BUILDINGS 5 & 6 RENOVATIONS

EXTERIOR ELEVATOR FOUNDATION PLAN

Date: 12/31/08
 Scale: AS NOTED
 Project Number: 07013
 Drawing Number: **S2.6**

ASI-17

2.6A FOUNDATION PLAN

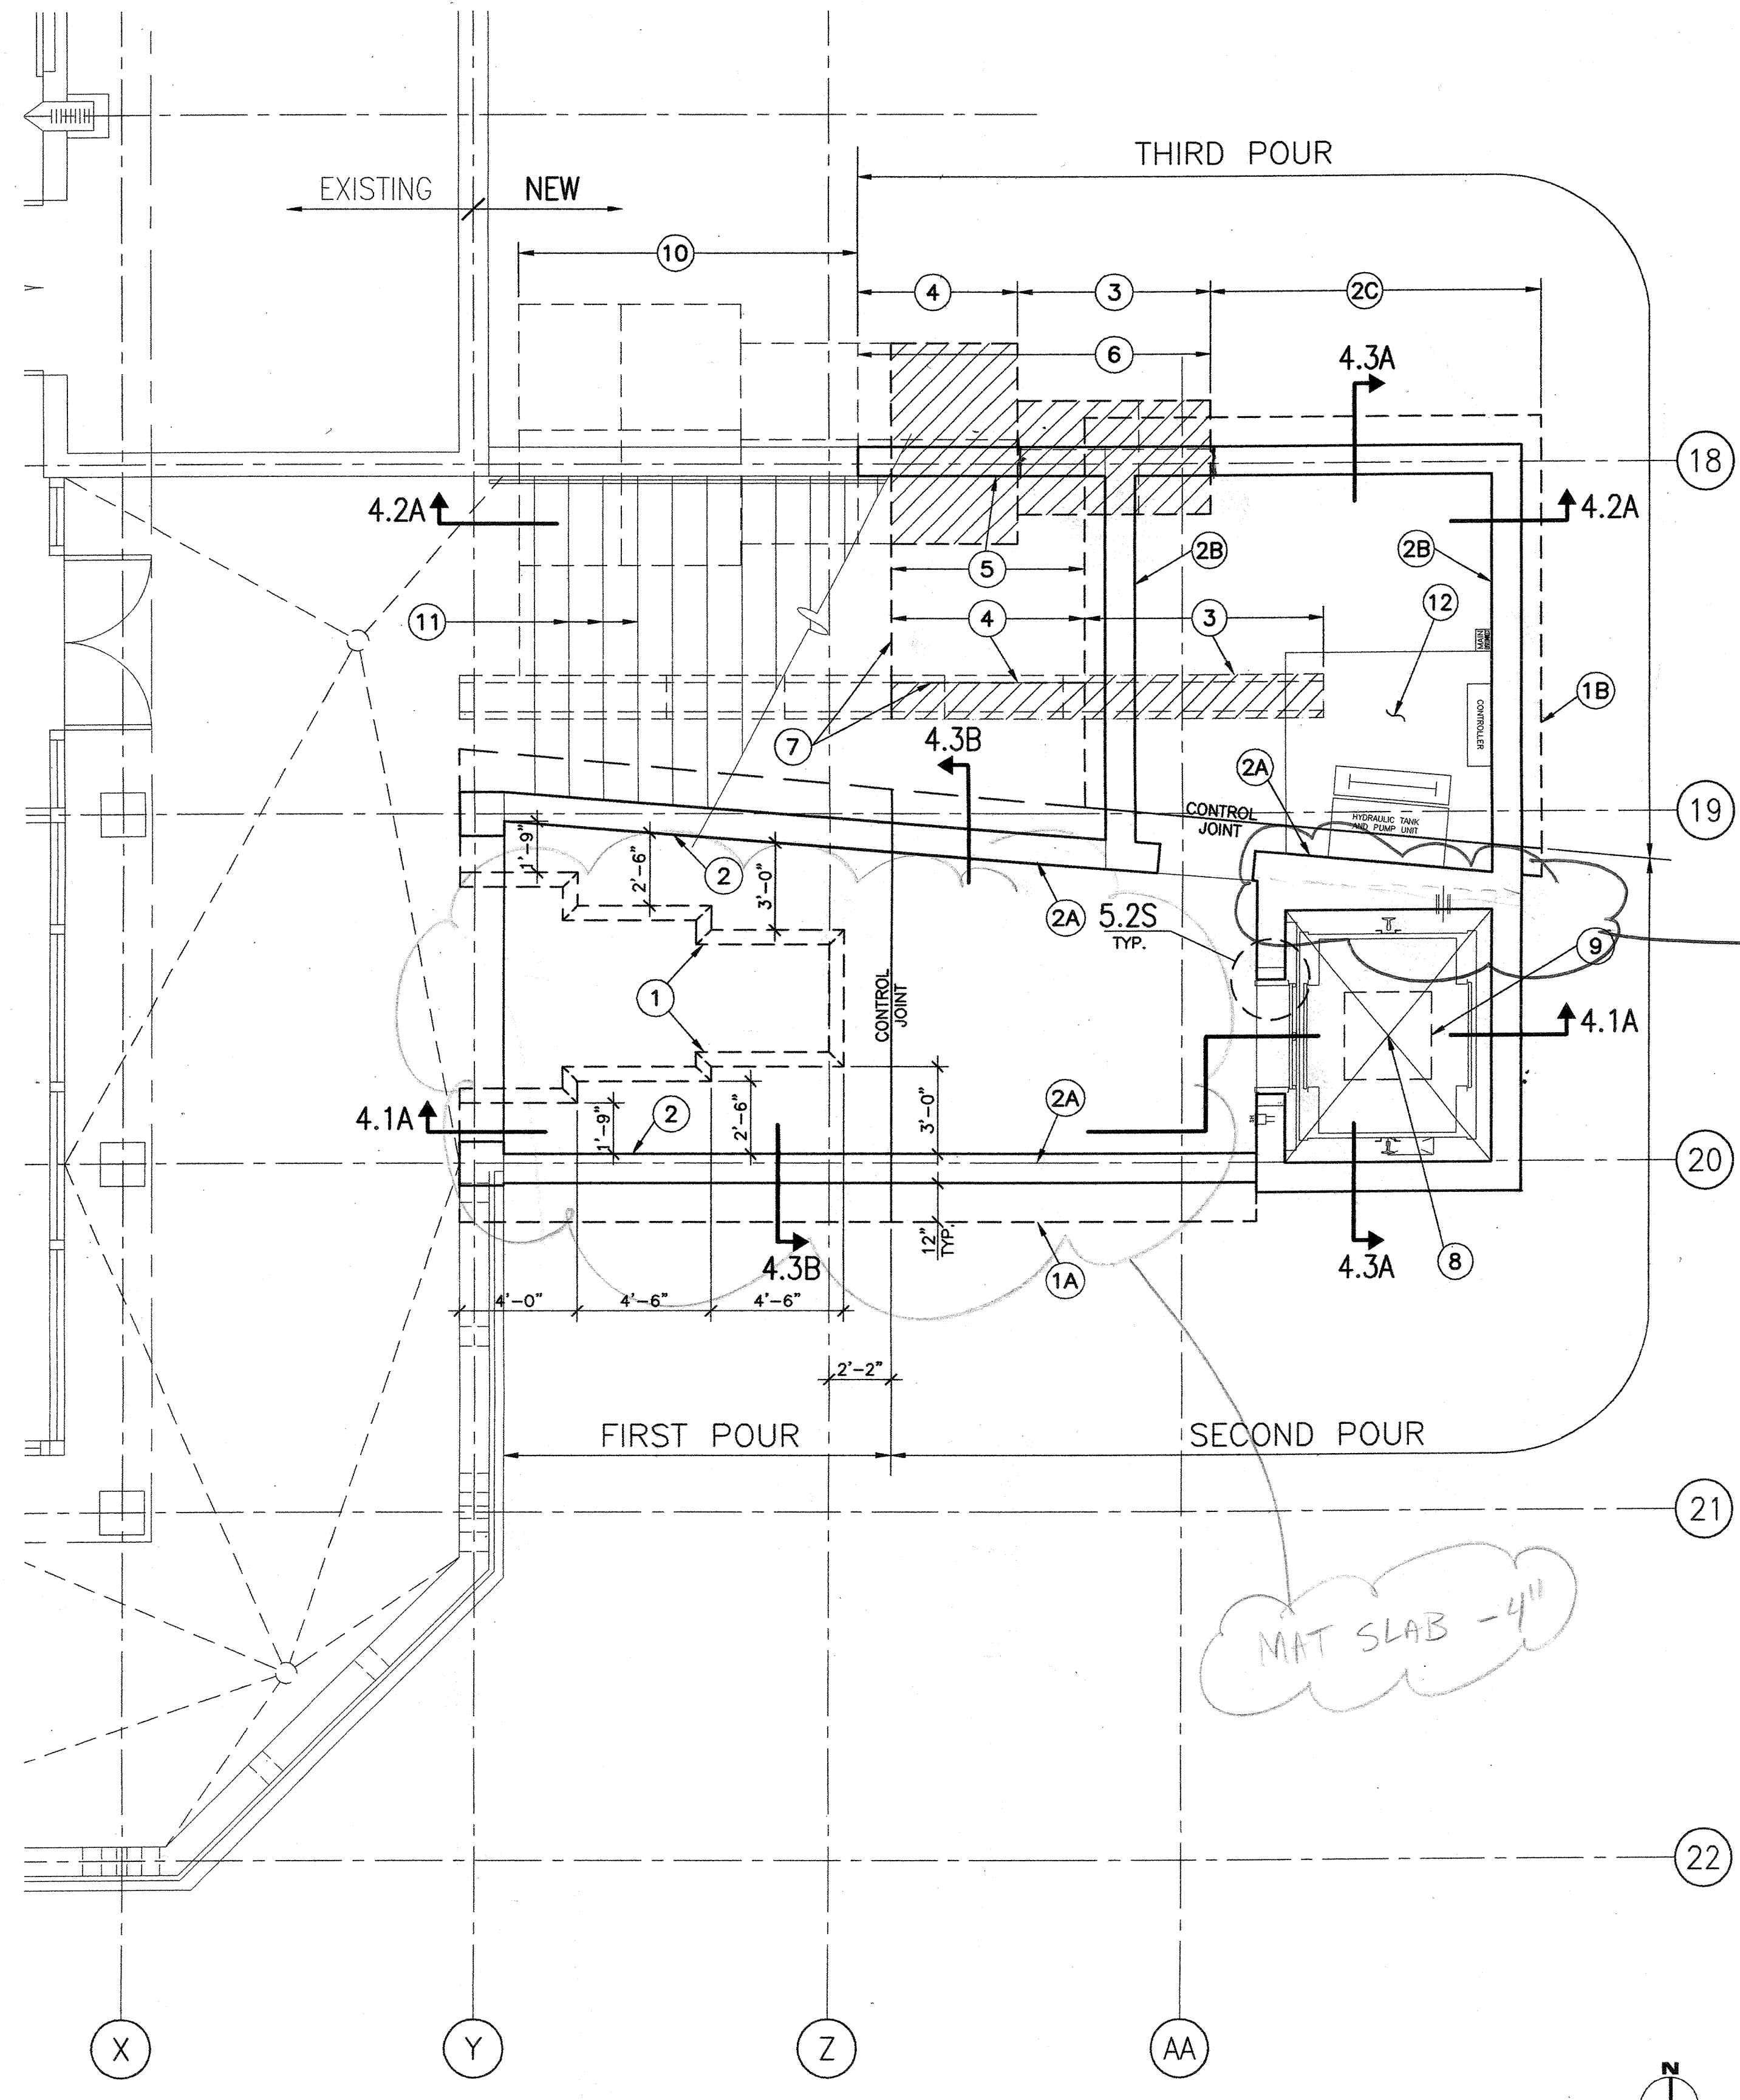
139. Sheet C1 notes an unreinforced 4" concrete slab over 4" base for the area of new slab in front of the new elevator and elevator room. However, details 2.6A/S2.6 and 4.3B/S4.3 indicate a 6" / 18" Response: Where notes/detailing conflicts, use the structural engineer's notes and details. Construct the new slab in front of the elevator room per structural detailing EXCEPT provide Solomon color "Rustique" per Owner's direction.

132. On sheet S2.6, note 6 requires the rebuild of the removed retaining wall and footing. However, while section 4.2A/S4.2 shows the height of the new footing and wall, the width of the new footing (and reinforcing required) is not shown in plan. Please provide the required width of the footing and its reinforcing requirements. Response: The footing thickness is 1'-6". The reinforcing for the wall and the footing is per Section S4.3B (S13). The width of the footing is 8'-0" centered on wall at Grid Line 18. The top of the footing is to match the existing footing at the approximate elevation 660'. The [N] footing and the wall are to be dove-tailed to the [E] footings and walls with #5 bars 30" long with 6" epoxy embedment at 18" o.c. The [N] footing is to start at approximately 1'-0" to the right of Grid Line Z and down to the [N] wall to the left of Grid Line AA with #5 bars 30" long with standard hook at the wall end spaced at 18" o.c.
